Technical Service Bulletin

GT40 Service Bulletin: 0601GT Engine Run On Key Off

GT40 Blower Fan Circuit

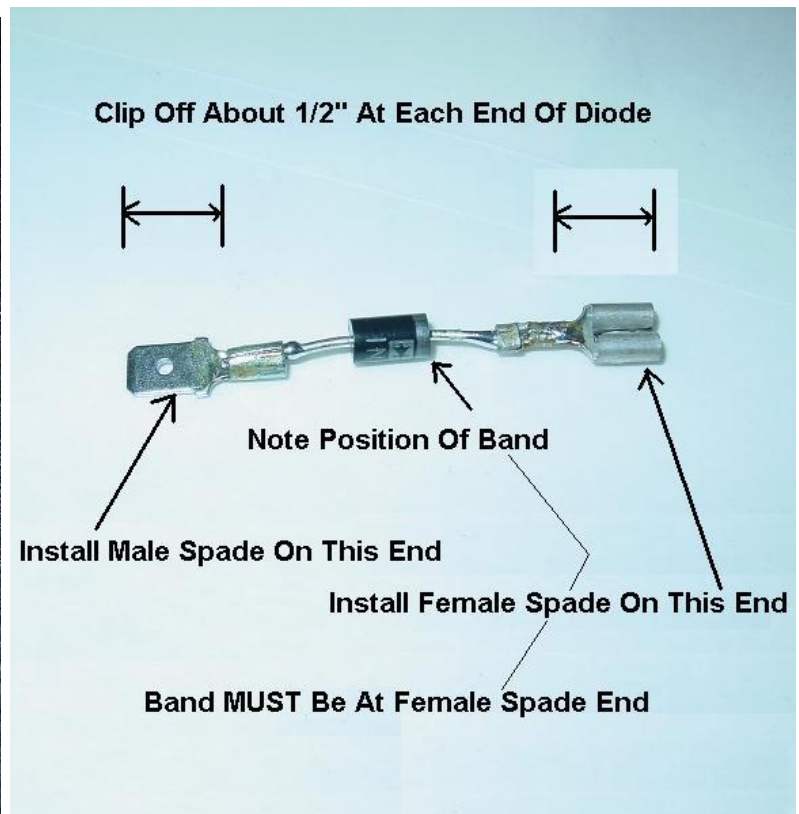
This has been traced to a voltage back feed problem in the A/C low speed fan relay circuit. The low speed fan relay activates when the A/C switch is turned on to keep air moving through the evaporator to prevent freeze up.

To prevent the run on condition the back feed just needs to stop long enough so that the low speed relay can shut down. Inserting a diode in the blower fan circuit as shown below can accomplish this.

If this condition is present, what is needed is a heavy-duty diode that can be obtained at Radio Shack®, part number 276-1141. You will also need a male and female spade terminal and shrink tube about 2" long.

1. Cut about a $\frac{1}{2}$ " off each end of the diode.
2. Note that the diode has a silver band on it. At the band end, install the female spade connector. No not simple crimp these on, crimp then solder the ends in place.
3. Install the male end on the opposite end.
4. Slide the shrink tubing over the diode, cover the female end but leave the male end bare.

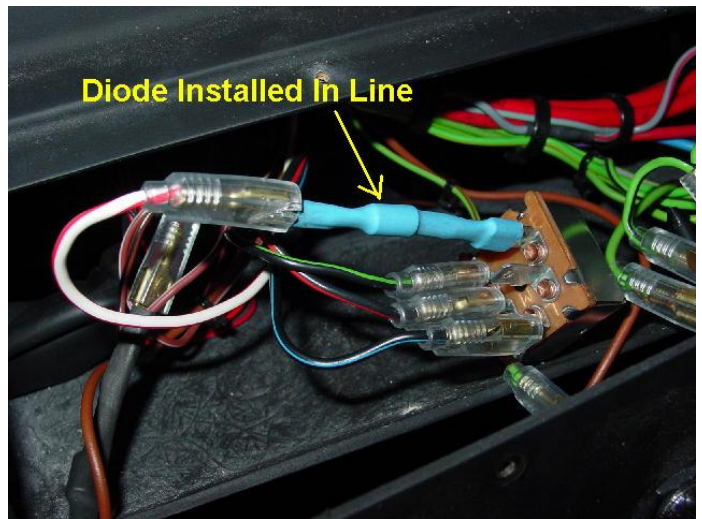
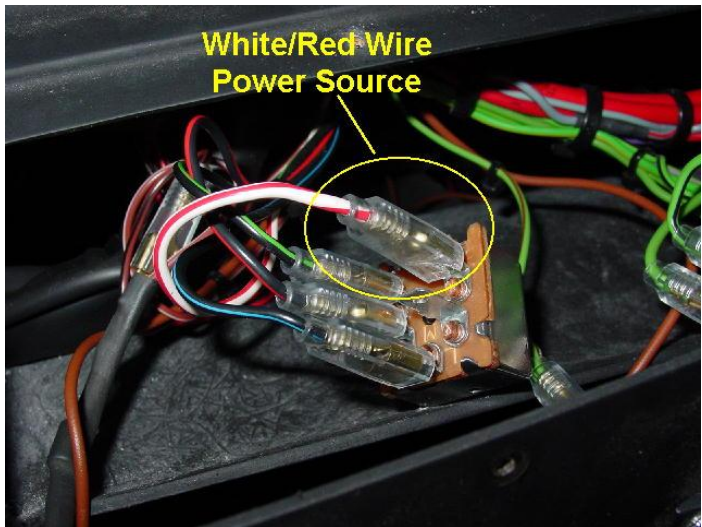
5. Shrink the tube around the diode as shown above left.
6. Remove the Switch panel screws as shown above right. Pull the switch panel out from the dash.
7. Find the fan switch (seconded from left) on the backside of the switch panel.
8. Locate the White/Red wire.
